From: Neil Duffield
Sent: 12 July 2022 09:49
To: Hilary Saunders <
Cc: lou
Subject: 22/0249 Low Farm, Sneaton E11107-41Nymnp info 12-07-22

From: Hilary Saunders
Sent: Tuesday, July 5, 2022 3:59 PM
To: Neil Duffield
Subject: 22/0249 Low Farm, Sneaton

From: Mark Antcliff
Sent: 09 June 2022 12:05
To: Planning
Subject: NYM/2022/0249 Low Farm, Sneaton

PROJECT: **Low Farm Sneaton**

DRAWING No: D11107-07	REV: E
-----------------------	--------

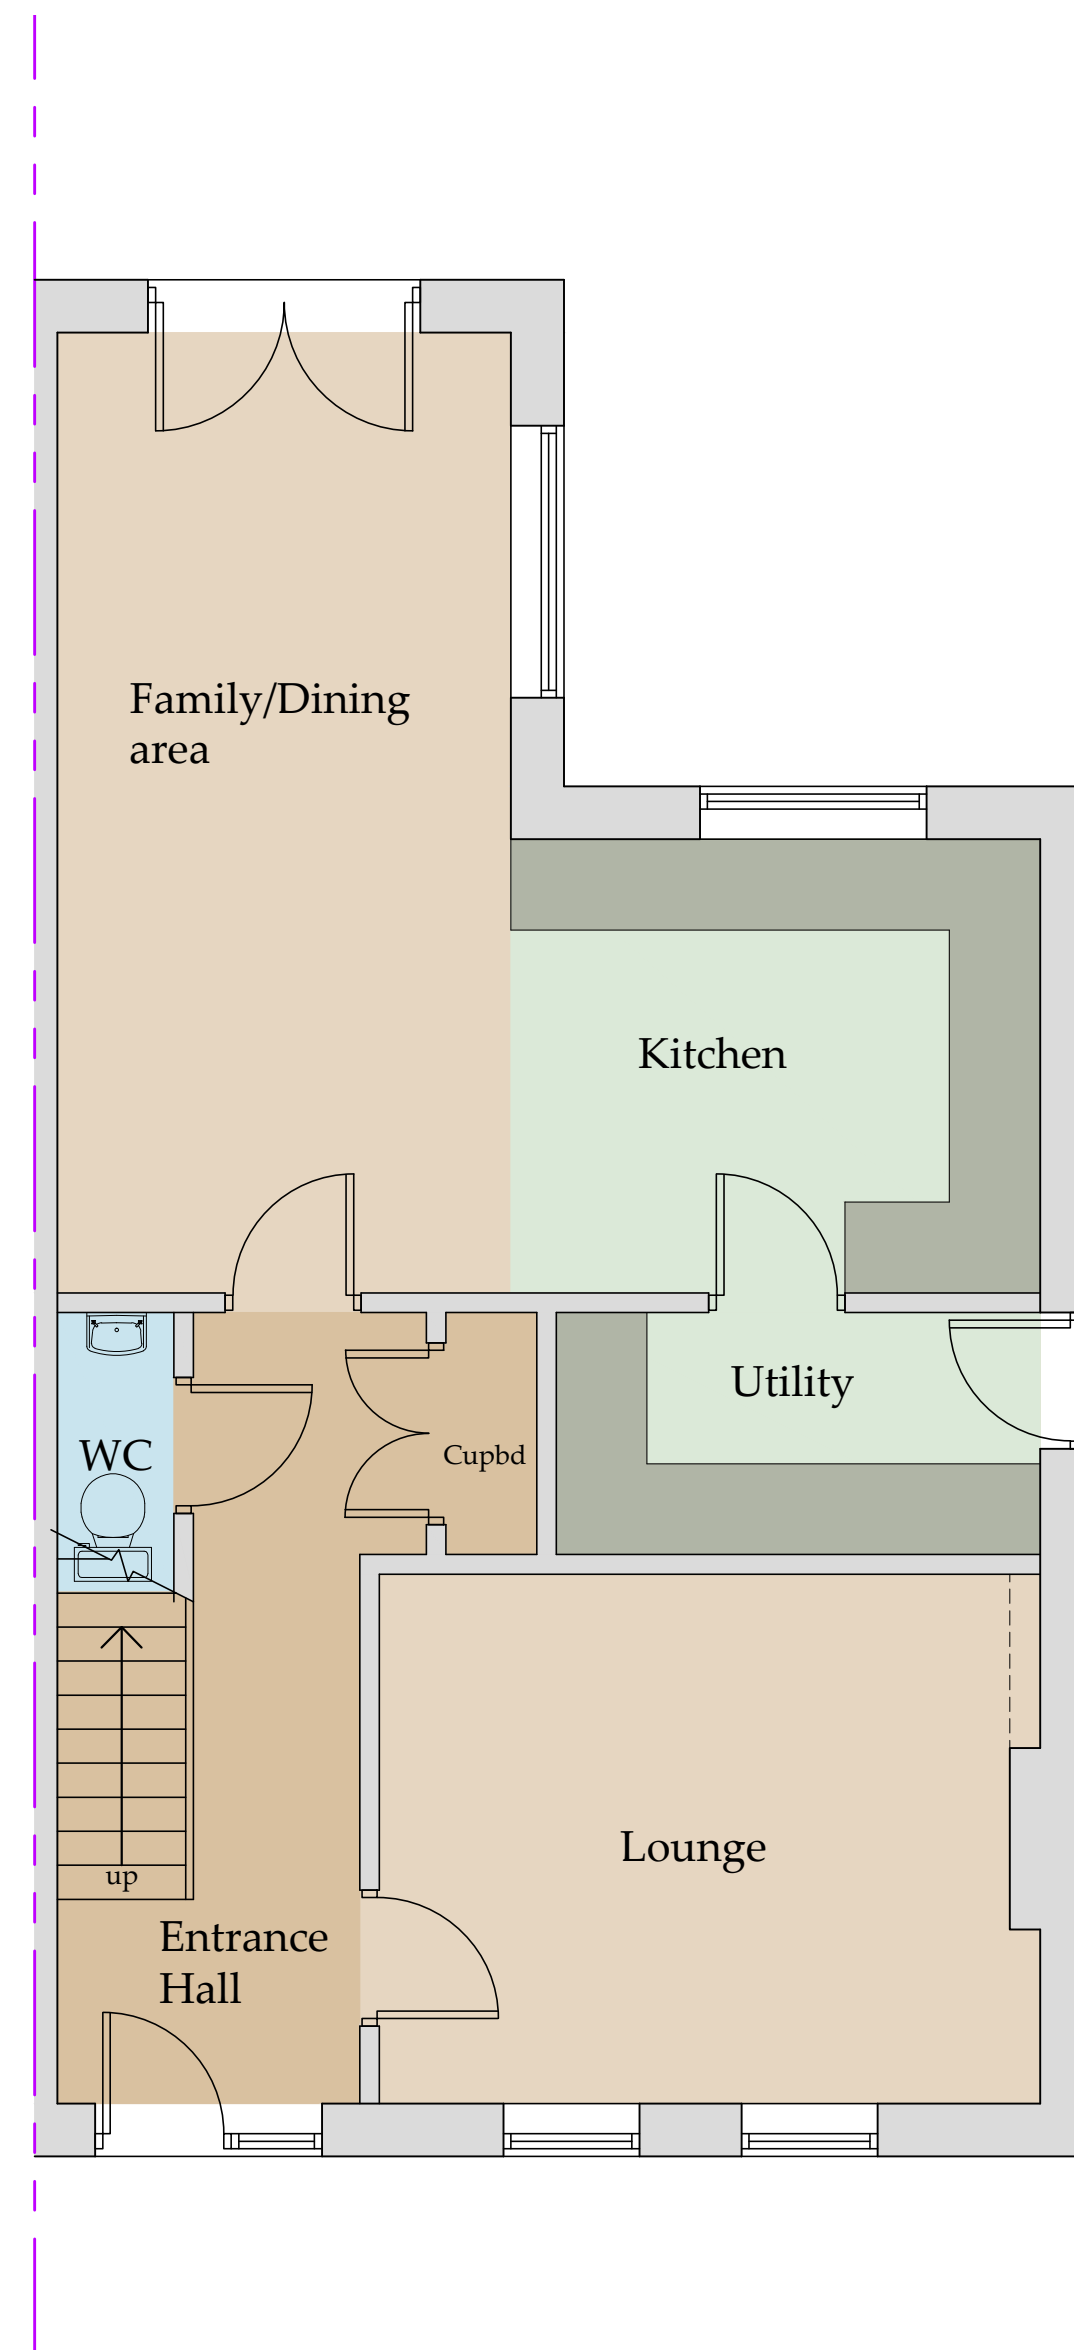
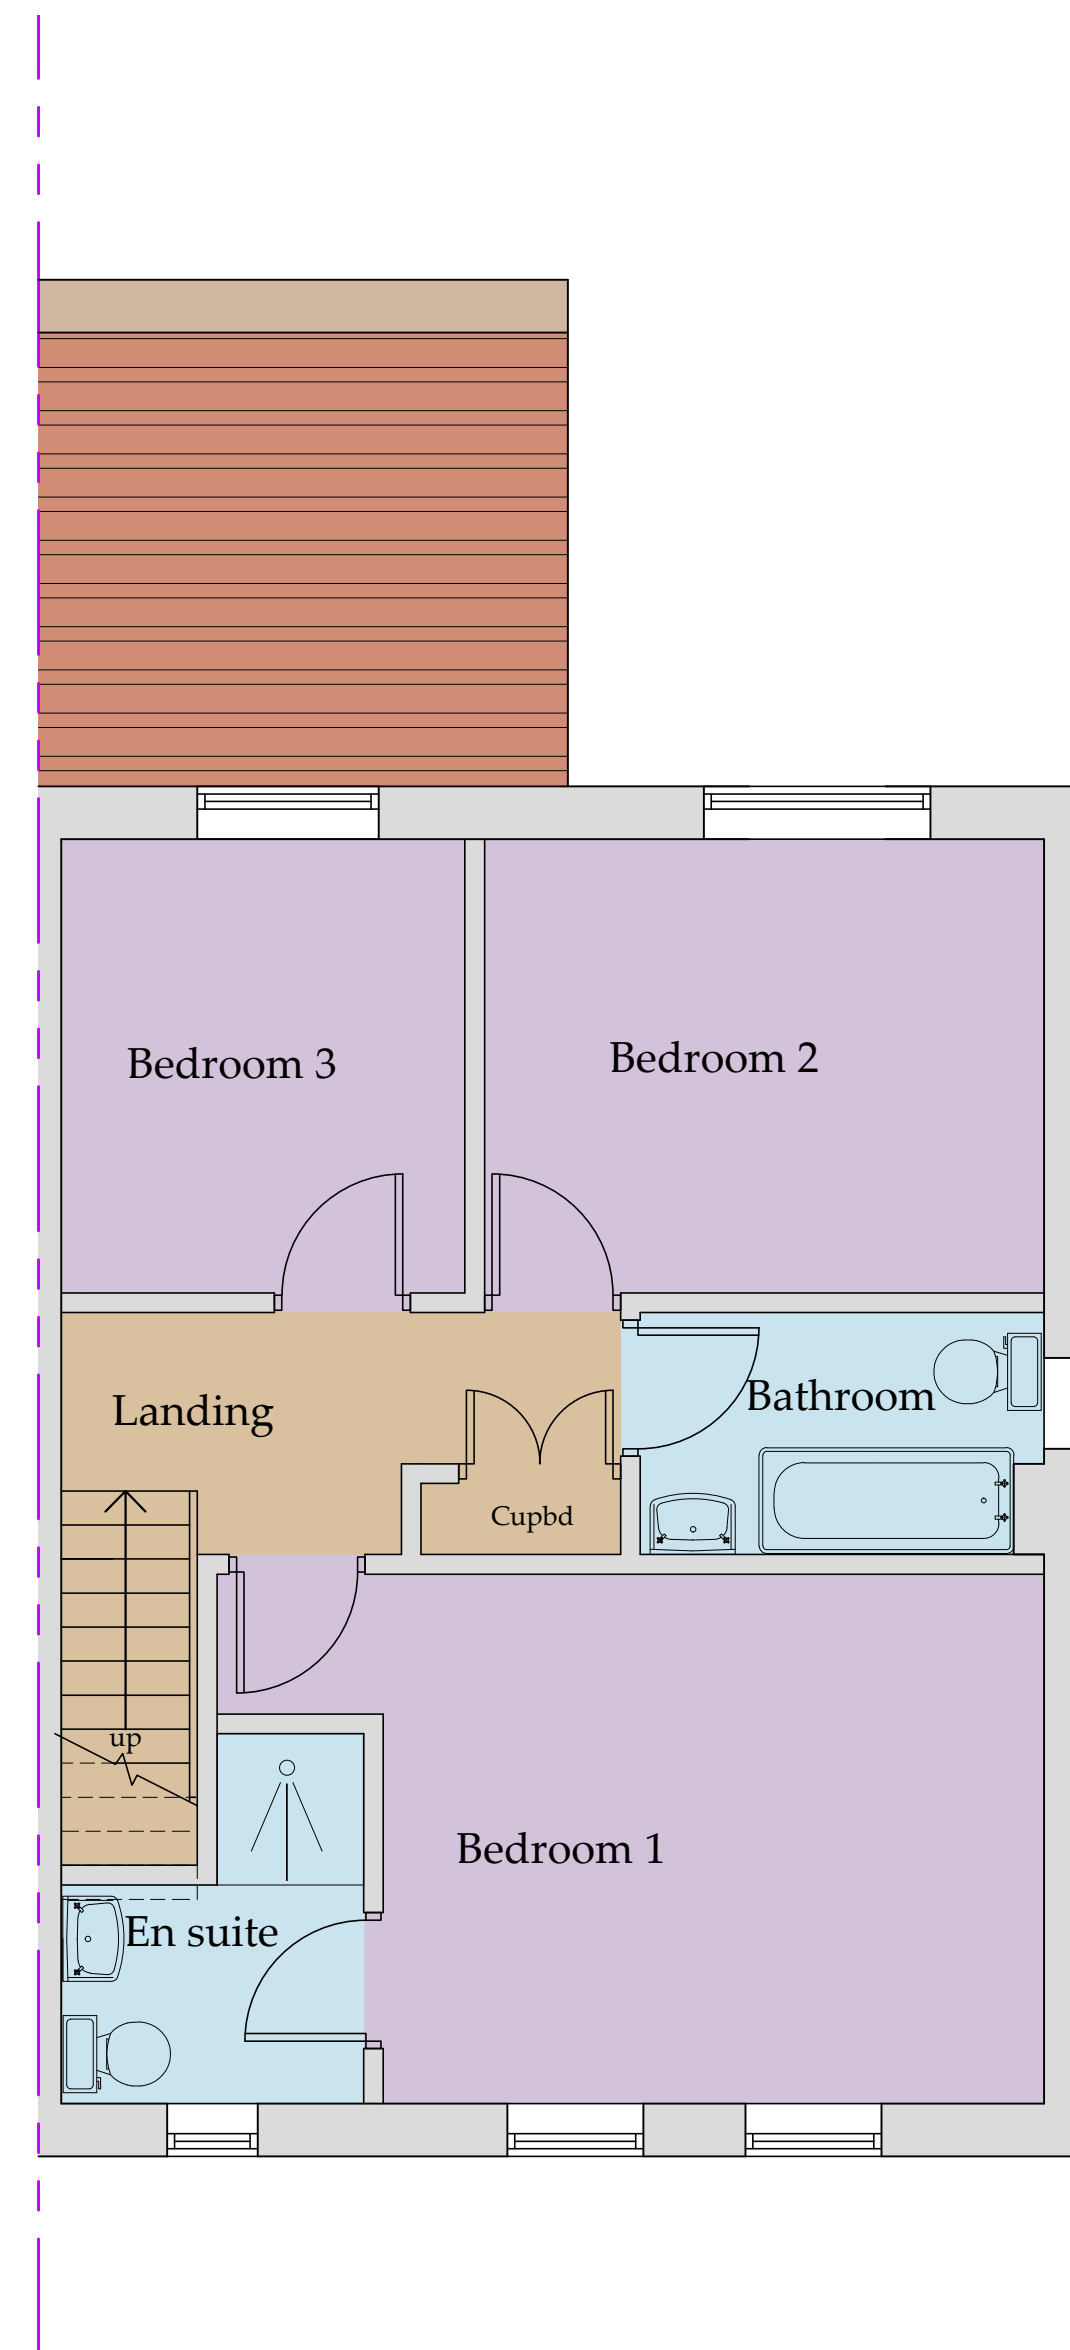
- Mark has suggested the inclusion of some slate roofs – what is your view?
- Still a lot of rear rooflights – can these be reduced further – would bedrooms be better with single longer rooflights and could ensuite have a gable end window?

5. We are happy with the addition of Slate to break up the roofscape and have shown Plots 3a and 3b with natural slate roofs.
6. The rooflights have been substantially reduced in number with the remaining single rooflights into bedrooms increased in height. Also as suggested the en Suite has a small window in the Gable.

E	11/07/22	CE	Roof to slate
D	08/06/22	CE	Solar panels added
C	08/03/22	CE	Lintels added
B	21/02/22	CE	Elevations added
A	16/12/21	CE	Issued for approval
